From: (b)(6) .NAVFAC MIDLANT, ROICC Camp Lejeune
To: (b)(6) .NAVFAC MIDLANT, BD; (b)(6) .NAVFAC MIDLANT, ROICC Camp
(b)(6) .NAVFAC MIDLANT, ROICC Camp Lejeune; (b)(6) .NAVFAC
MIDLANT, Staff
Subject: Correspondence Regarding JT Yates Electric Service, Freedom of Information Act (FOIA) Request DON-NAVY-
2017-003161 - Camp Lejeune - P1383 & P1384 Base Entry Point / CLEO Building Projects Contract No. K1310-
002-S / Project Number K1310 SLO Case No. 16-970
Date: Friday, May 12, 2017 13:04:56
Attachments: [Non-DoD Source FW Rack Add at CLEO.msg](#)
[RE Rack Add at CLEO.msg](#)
[Non-DoD Source FW J.T. Yates Electric Service Inc. Group III Mgt. Inc. \(16-9704\).msg](#)
[Non-DoD Source FW RFP-063 CLEO LOCKERS AND ELECTRICAL CHANGES.msg](#)
[Non-DoD Source RFP-063 CLEO LOCKERS AND ELECTRICAL CHANGES.msg](#)
[RE ROADWAY LIGHTS ON AT WILSON GATE.msg](#)
[Non-DoD Source FW ROADWAY LIGHTS ON AT WILSON GATE.msg](#)
[Non-DoD Source Fwd ROADWAY LIGHTS ON AT WILSON GATE.msg](#)

Response to Request for Information - P1383/4 New Base Entry Road and Base Entry Point

DATE:	26 February 2016
FROM:	(b)(6)
SUBJECT:	RESPONSE MEMO: RFI No. 331
TO:	(b)(6) - OICC MCI East, MCB Camp Lejeune
COPY TO:	(b)(6) PE

GATEHOUSE ELECTRICAL RISER DIAGRAM
SCALE: NOT TO SCALE

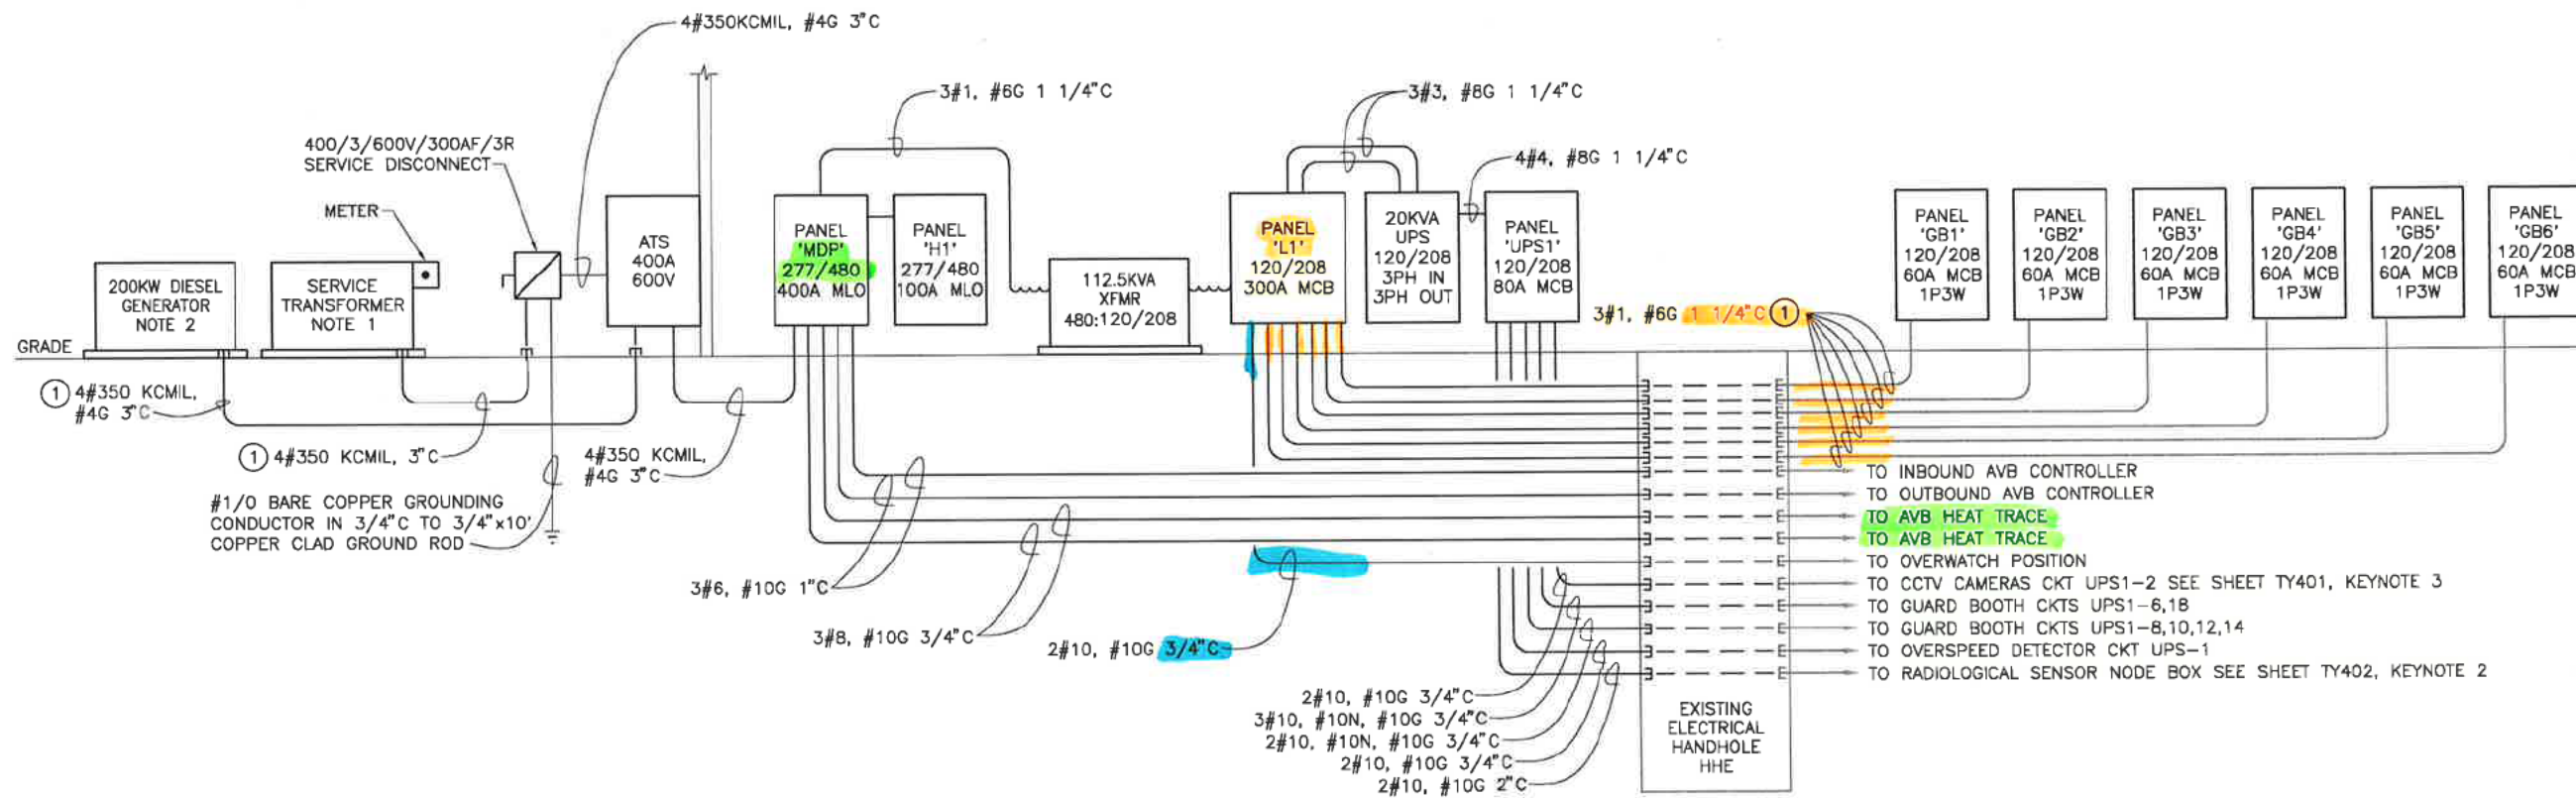
Good afternoon. Please see the attachment. EP601 indicates that the AVB heat trace is to enter the MDP panel which is 277/480 voltage. The attached photos show the AVB heat trace data plate which calls for 120 volt.

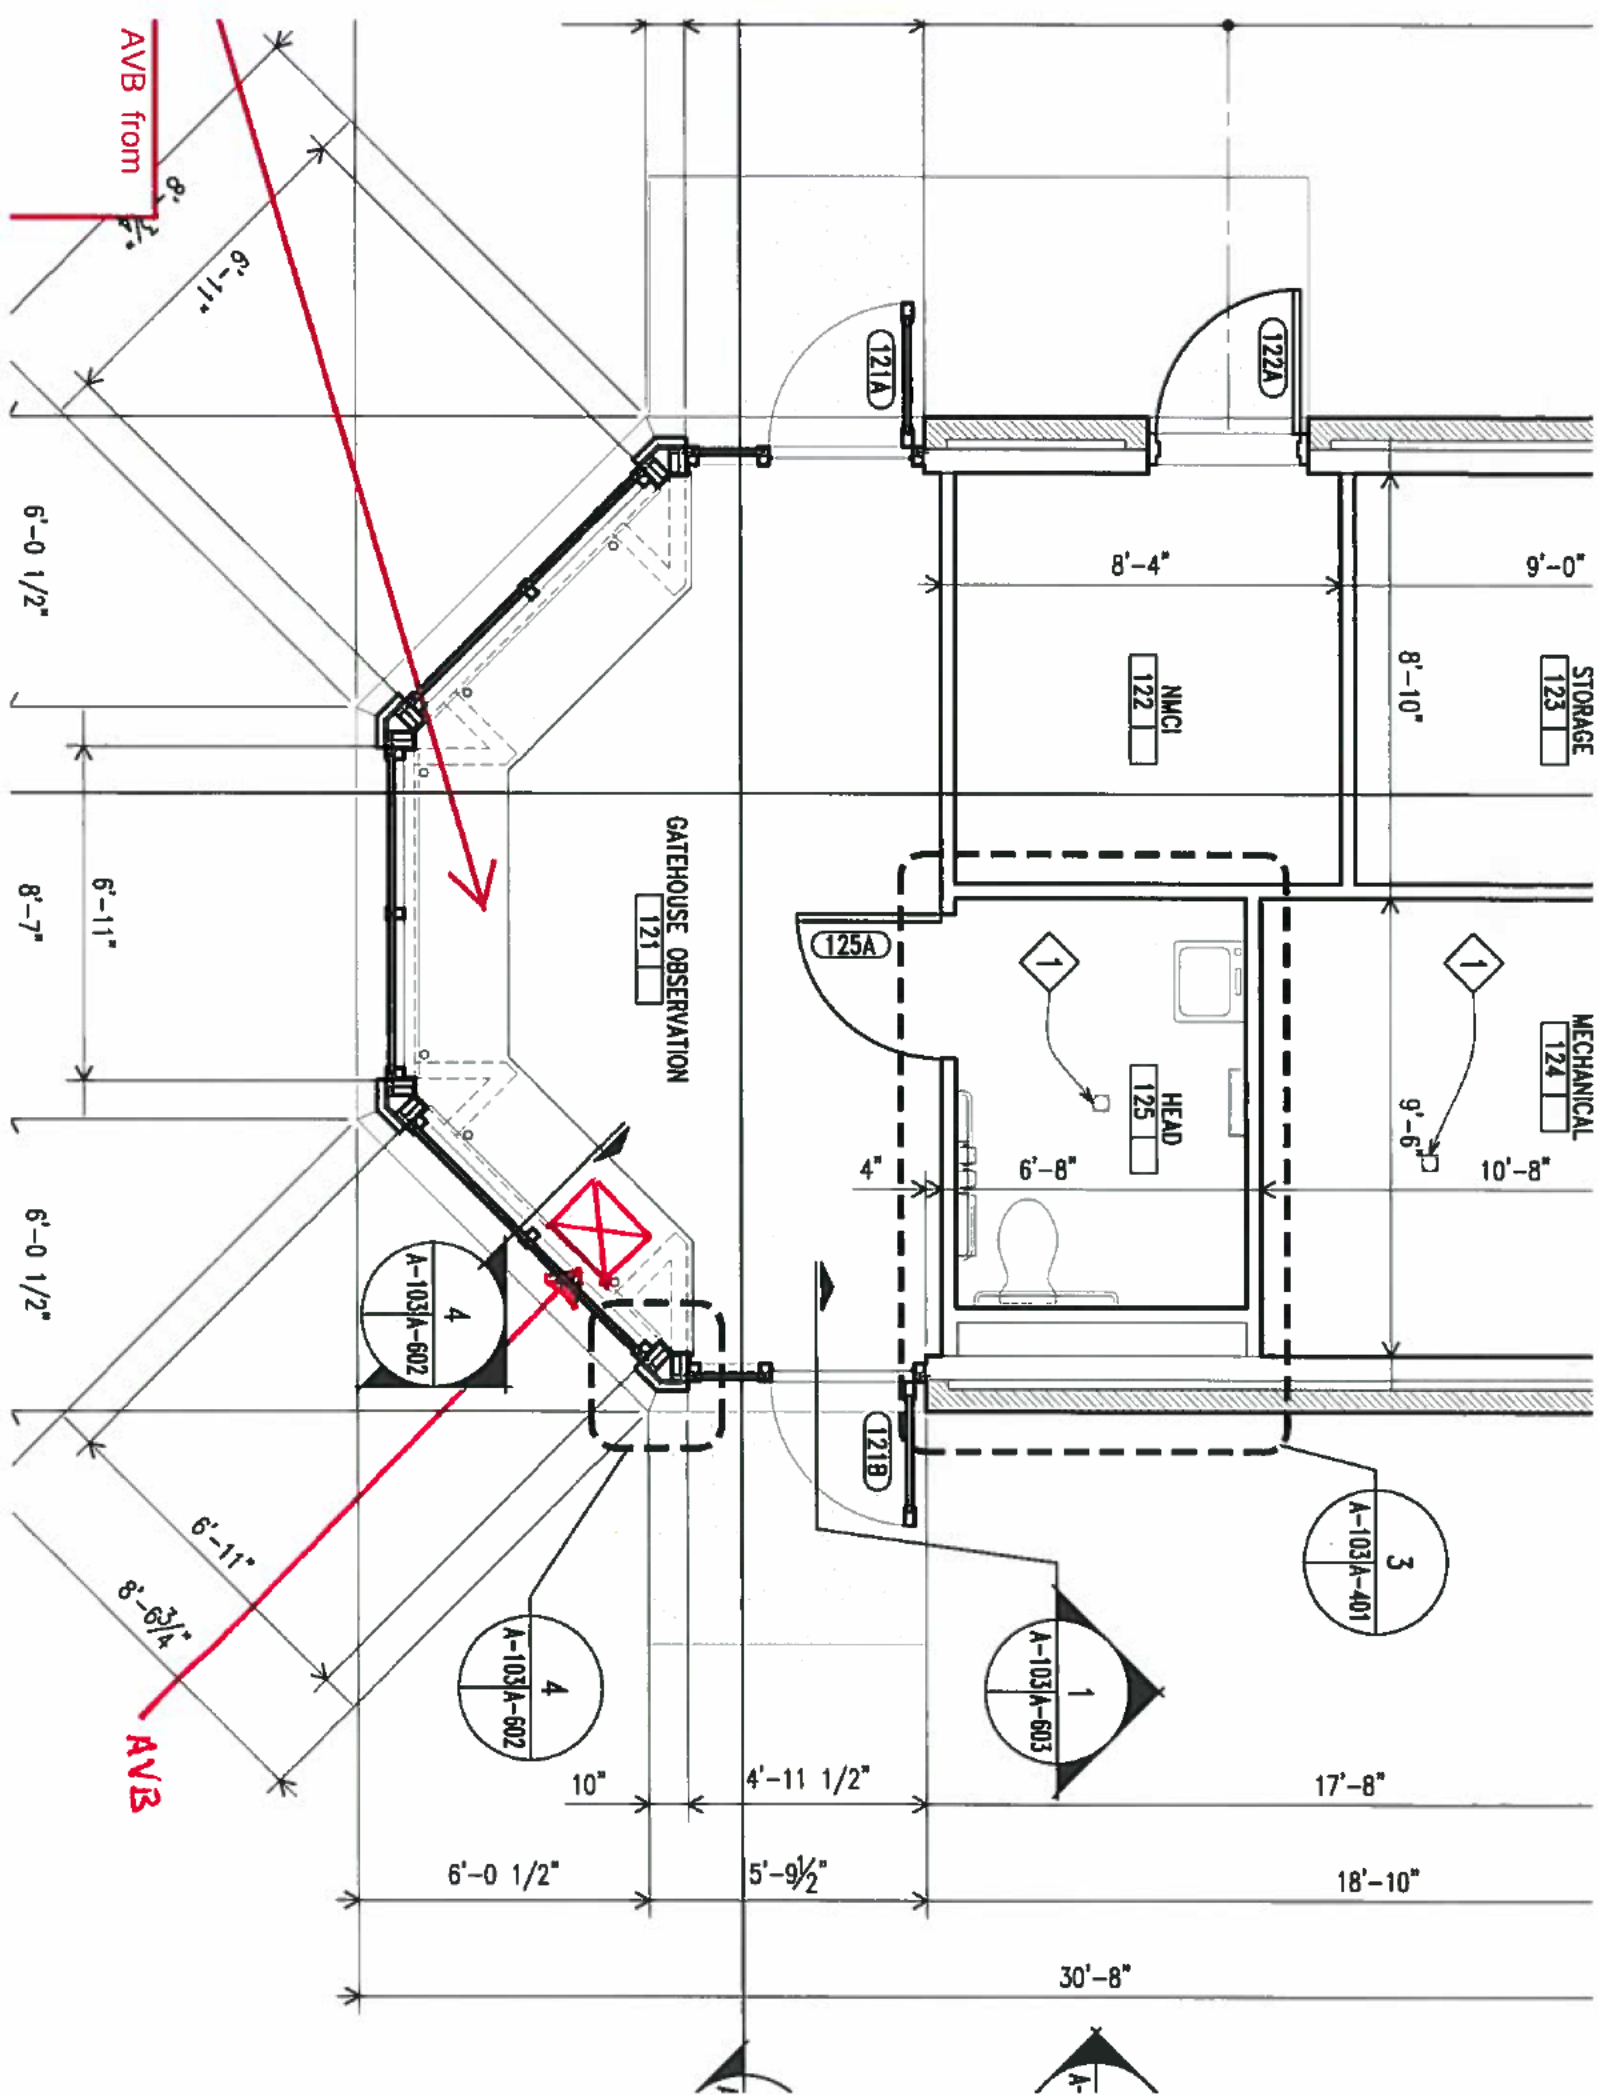
See attached drawing for where PMO would like the AVB button moved to. In addition the base wants the light removed that is right in front of the gatehouse that we have spoken about previously. Consider this your RFP. Please provide your proposal by 21 DEC 2015.
